South Coast Air Quality Management District
21865 Copley Drive, Diamond Bar, CA 91765-4182
(909) 396-2000 • www.aqmd.gov

Re: Appeal from March 7, 2013 decision of the Port of Los Angeles-Board of Harbor Commissioners to approve the Final Environmental Impact Report for the Southern California International Gateway Project and associated approvals (ADP No. 041027-199/SCH No. 2005091116)

The South Coast Air Quality Management District (SCAQMD) is writing to appeal the March 7, 2013 decision of the Los Angeles Board of Harbor Commissioners to approve the Final Environmental Impact Report for the Southern California International Gateway (SCIG) project and any associated approvals, including, but not limited to, the Findings of Fact, the Statement of Overriding Considerations, and the Mitigation Monitoring and Reporting Program. This appeal is made pursuant to Public Resources Code section 21151(c).

Figure 1: Surrounding Residential and Sensitive Land Uses Near Proposed SCIG Facility

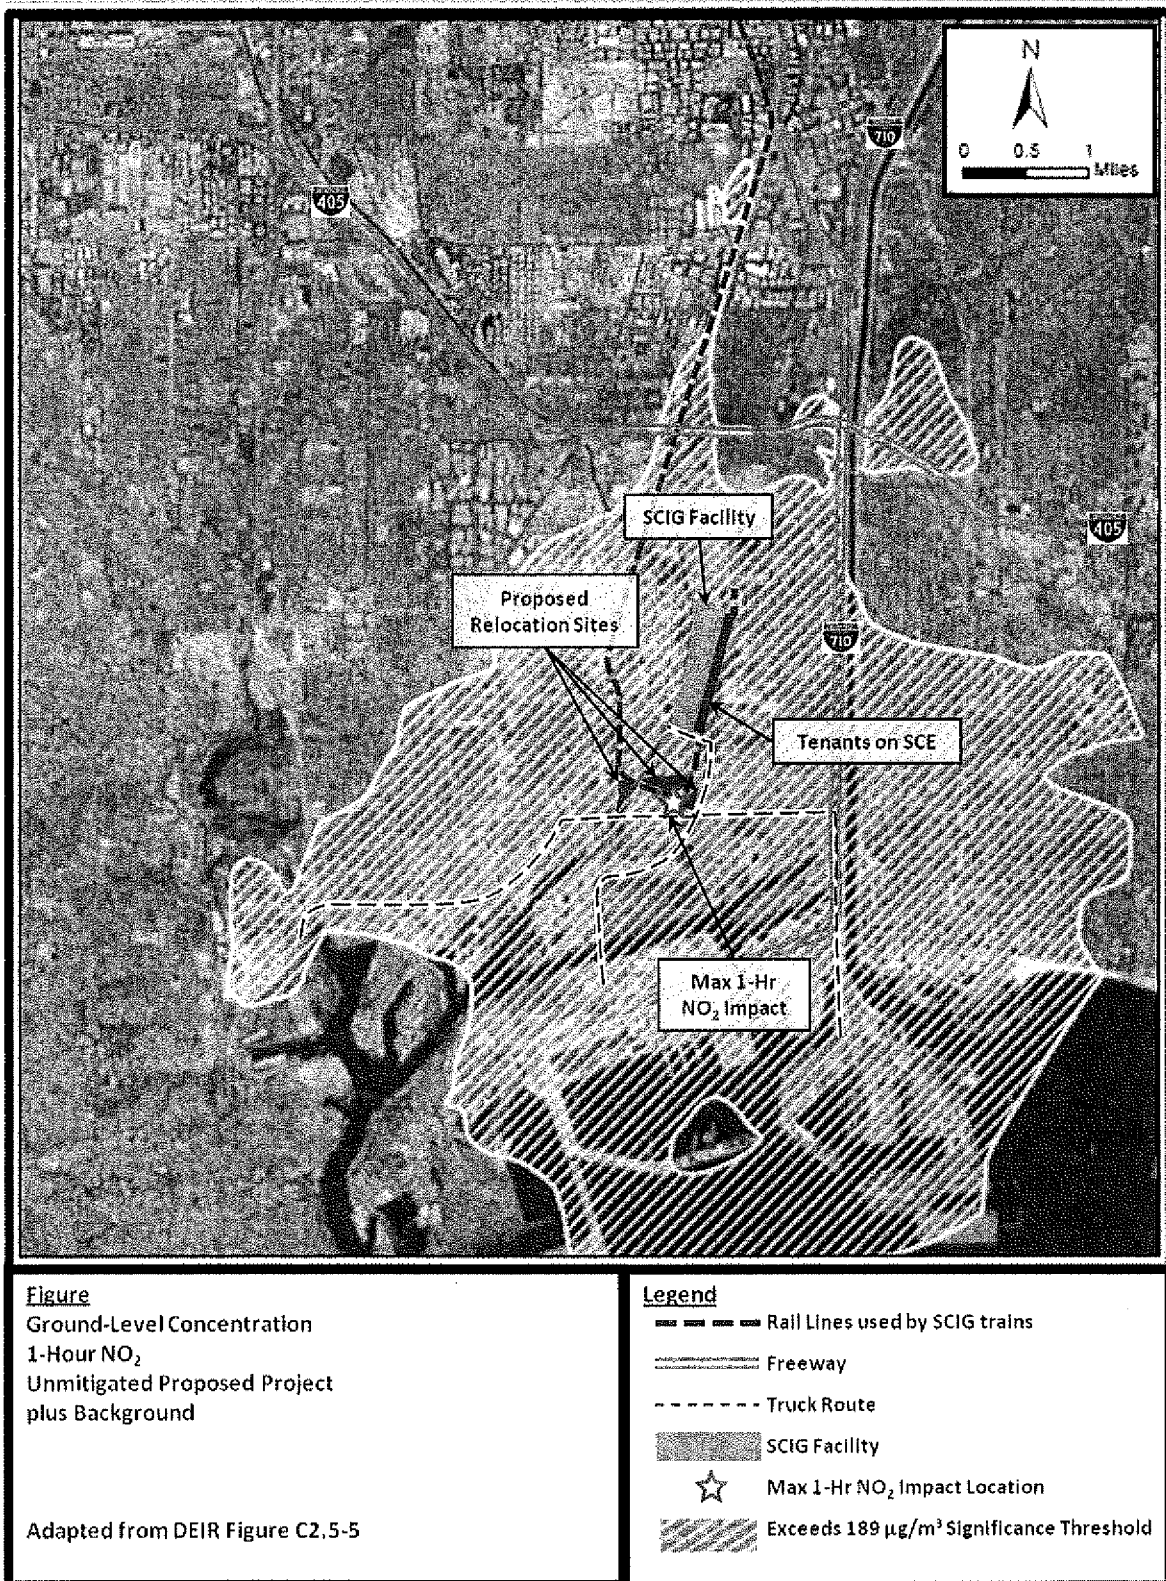
The South Coast Air Quality Management District (SCAQMD) staff appreciates the opportunity to comment on the Draft Environmental Impact Report (DEIR) for the Southern California International Gateway (SCIG) Project. Our comments seek an EIR that fully evaluates and discloses environmental impacts of the project, and that identifies for the proposed project's decision makers all feasible measures to mitigate significant impacts. Air quality impacts of the Proposed SCIG project must be carefully evaluated and mitigated because the railyard will be one of the largest intermodal facilities in the nation, and will be located near residences, schools, a pre-school, and a veterans center. The West Side neighborhood of Long Beach is home to approximately 13,500 residents¹ and lies between the project site and the I-710 freeway, but as close as 1,000 feet from the proposed project. In addition, Hudson School, an elementary and middle school with over 1,000 students, is less than 600 feet from the eastern boundary of the proposed Project site². The Mary Bethune School and Cabrillo Child Development Center are less than 500 feet from the eastern boundary of the proposed site. See Figure 1.

Figure 2: 1-Hour NO₂ Unmitigated Impacts

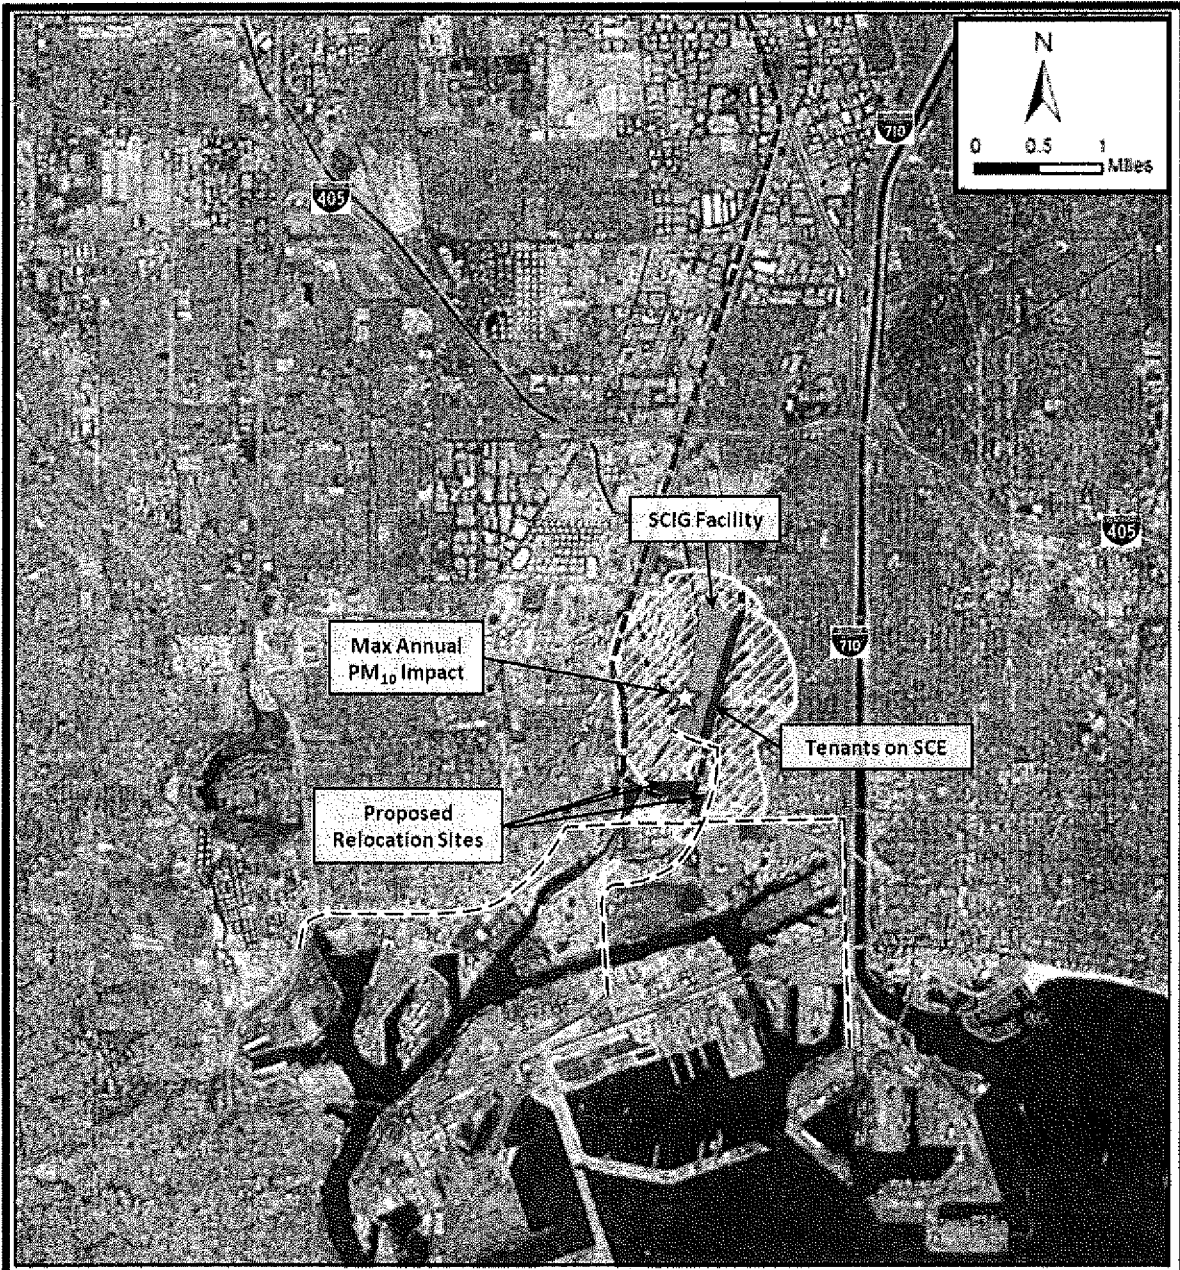
The Proposed SCIG Project will result in significant localized impacts of NO₂ and PM₁₀. As depicted in Figure 2 below, NO₂ is expected to exceed federal standards over a wide area, including population centers in west Long Beach and Wilmington. Concentrations of NO₂ in the community from the project alone are predicted to exceed the federal standard by at least a factor of five (Table 1 below). The modeled point of maximum NO₂ impact is located adjacent to the relocated tenants south of the project site. PM₁₀ impacts are predicted to exceed the annual and 24-hour SCAQMD Air Quality Significance Threshold by a factor of about 20. The area of PM₁₀ impact also extends into the west Long Beach community adjacent to the SCIG facility (Figure 3 below).

**Figure 1
Simplified Air Quality Dispersion Modeling Process Flowchart**

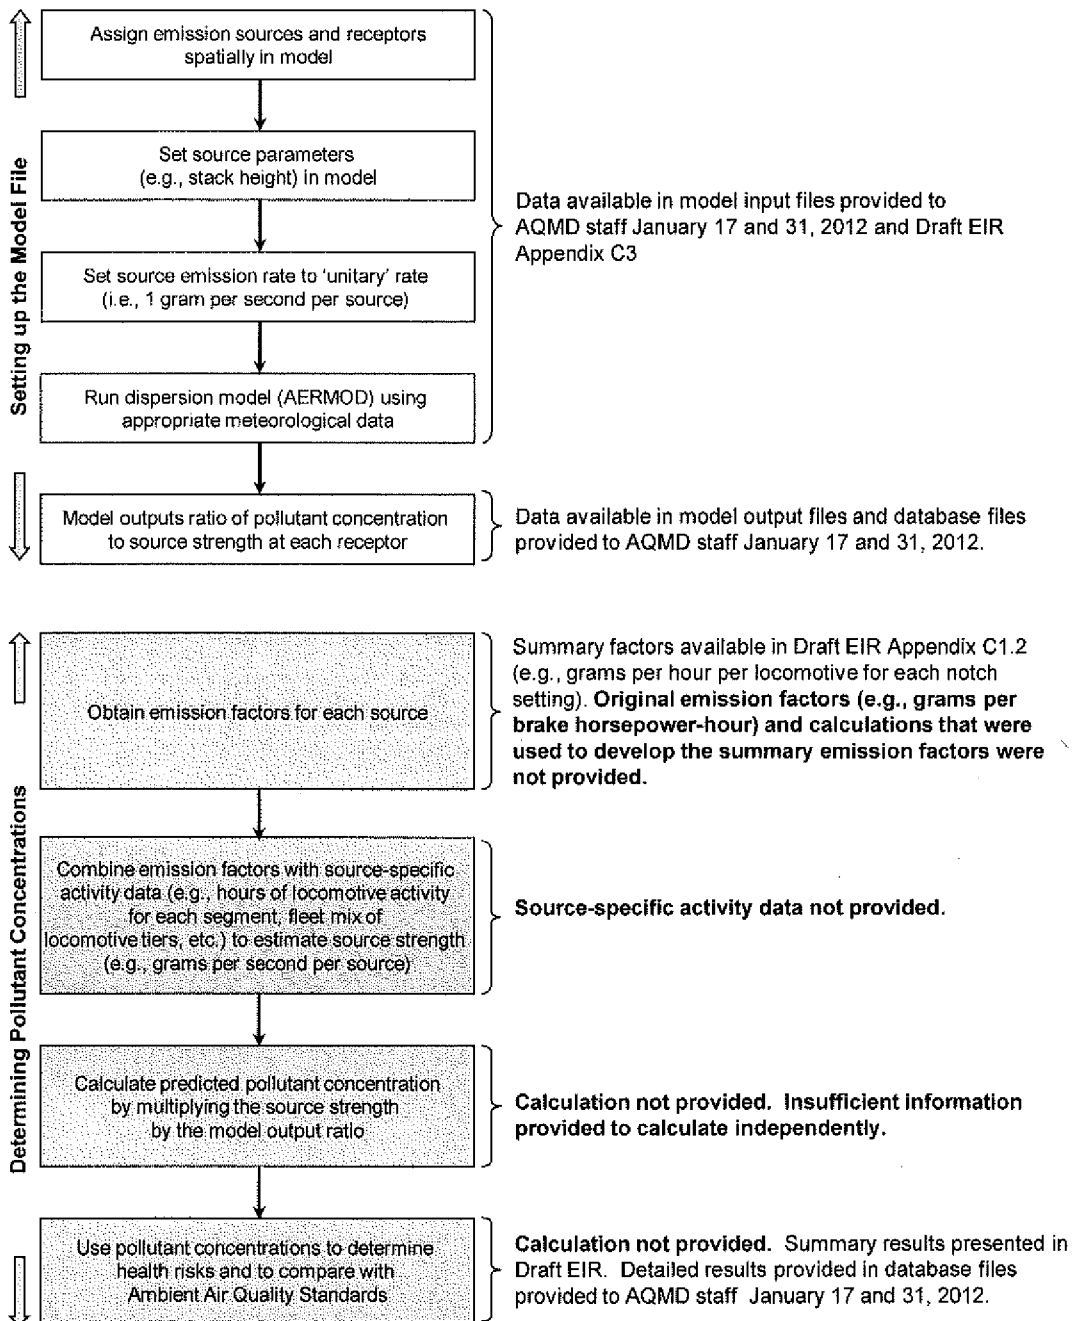
Figure 1 below presents a simplified flow chart describing the steps that are followed to convert emission factors into predicted pollutant concentrations using a dispersion model like AERMOD. As can be seen in the figure, critical data was not provided to AQMD staff or to the public. This data is necessary to confirm the validity of the results of the dispersion modeling analysis. A

Note: Shading indicates information not provided that is critical to calculating pollutant concentrations

Figure 3

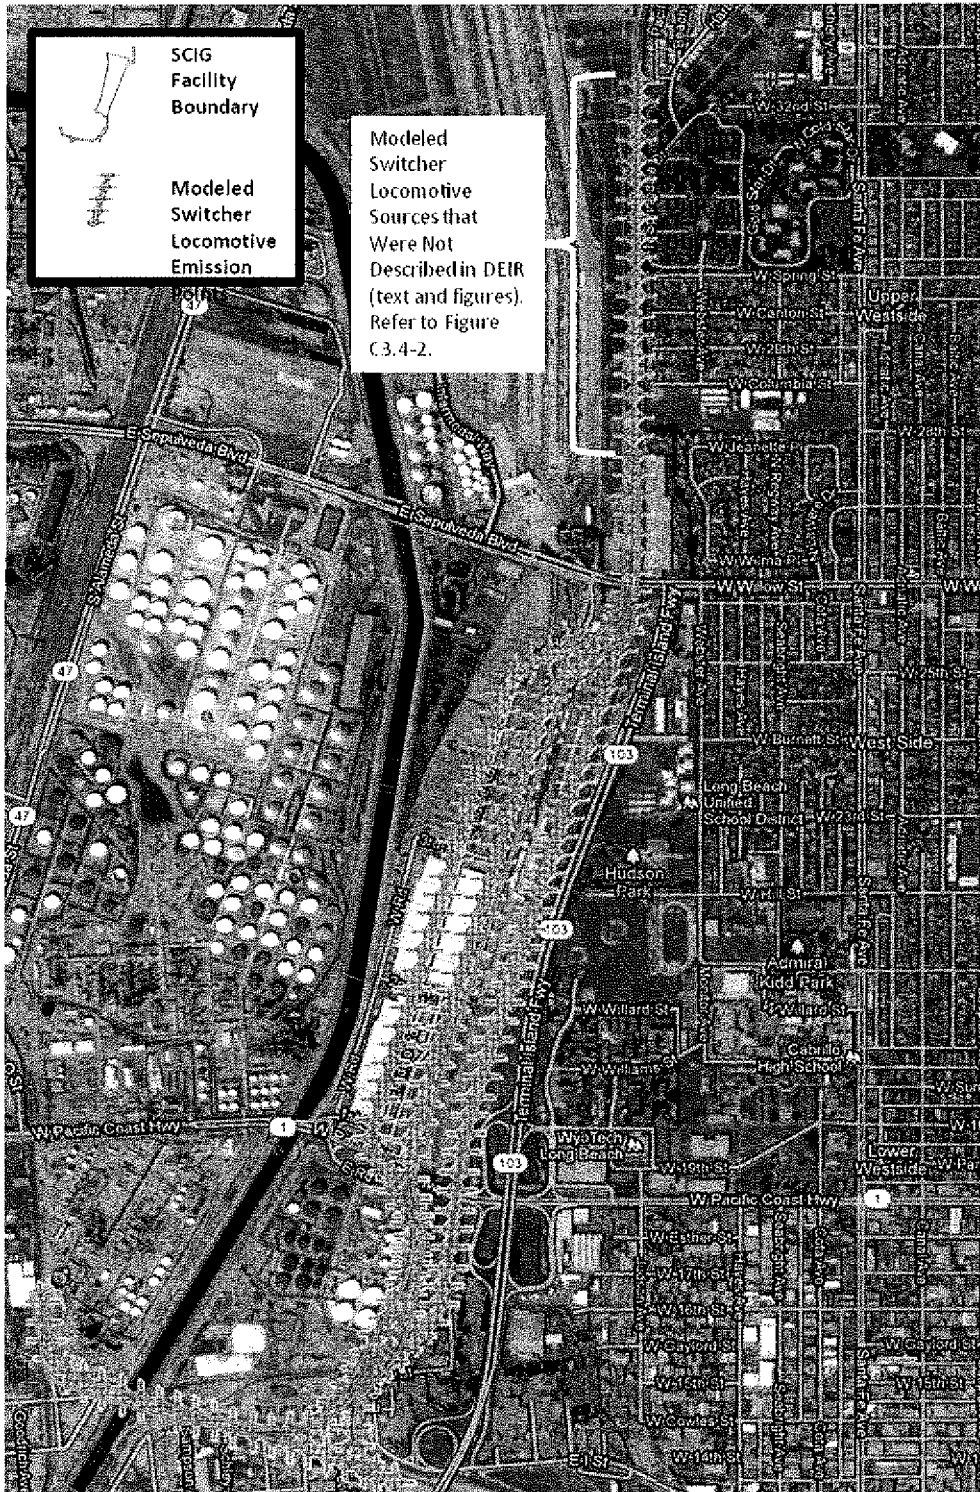
Although emissions calculations used to conduct to air dispersion modeling could not be completely reviewed, the location of emission sources was available. There appears to be a disconnect between the text of the DEIR and the location of locomotives that were modeled for the proposed project. The DEIR shows (Figure 2) locomotive emissions along the San Pedro Branch Line would occur south of Stephens Middle School. In the modeling files (Figure 3) the locomotive emissions along the San Pedro Branch Line extend well north of Stephens Middle School near the residential community of West Long Beach. If the proposed project will result in locomotives operating on the northern portion of the San Pedro Branch Line, that should be appropriately reflected in the DEIR, such as in Figure 3.

Locomotive Peak Daily Emissions

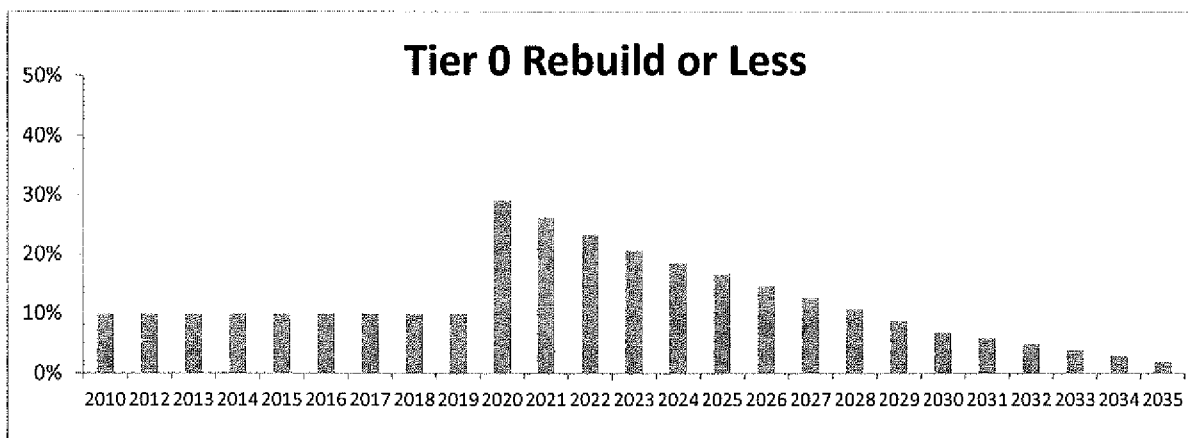
The Recirculated DEIR contains insufficient information for the public to determine the reasonableness of the locomotive peaking factor used to calculate peak day locomotive emissions. In the Draft EIR, peak day locomotive emissions were estimated assuming that all daily locomotive trips on the peak day were conducted by the lowest Tier level locomotive in the fleet mix for each analysis year. The AQMD staff did not comment on this approach because it was conservative, in that it produced locomotive emissions based on the highest emission rate available in the projected fleet. However in the Recirculated DEIR, peak day locomotion emissions were determined by applying a peaking factor to all future year locomotive emission factors. The peaking factor used in the Recirculated DEIR has substantial impacts on the locomotive emissions reported for the proposed Project. For instance, the 2035 NO_x emissions for the proposed Project in the Recirculated DEIR and Draft EIR were 916 pounds per peak day and 3669 pounds per peak day, respectively. This amounts to a 75 percent drop in off-site NO_x locomotive emissions in 2035. The peaking factor used in the Recirculated DEIR was derived by assuming a ratio of the peak day locomotive fleet mix average emissions factor in 2010, to the average day locomotive fleet mix average emissions factor in 2010. No supporting data or information is provided in the Recirculated DEIR on the underlying assumptions that went into deriving the peaking factor. As a result, the AQMD staff is unable to verify that the peaking factor is reasonable.

The application of the peaking factor to future locomotive emission rates further exacerbates the belief of AQMD staff that future locomotive fleet mixes, assumed in the emission rates tables of Appendix C1.2-21 and C1.2-22, over-predict the penetration of Tier 4 locomotives in milestone years 2023 and 2035. When coupled with the peaking factor, it results in an underestimation of the emission rates (and therefore emissions) for the peak day scenario. The approach used in the Draft EIR avoided this problem somewhat by assuming that the peak day emission rates were based on the lowest tier (highest emission rate) locomotive making up the fleet in a specific year.
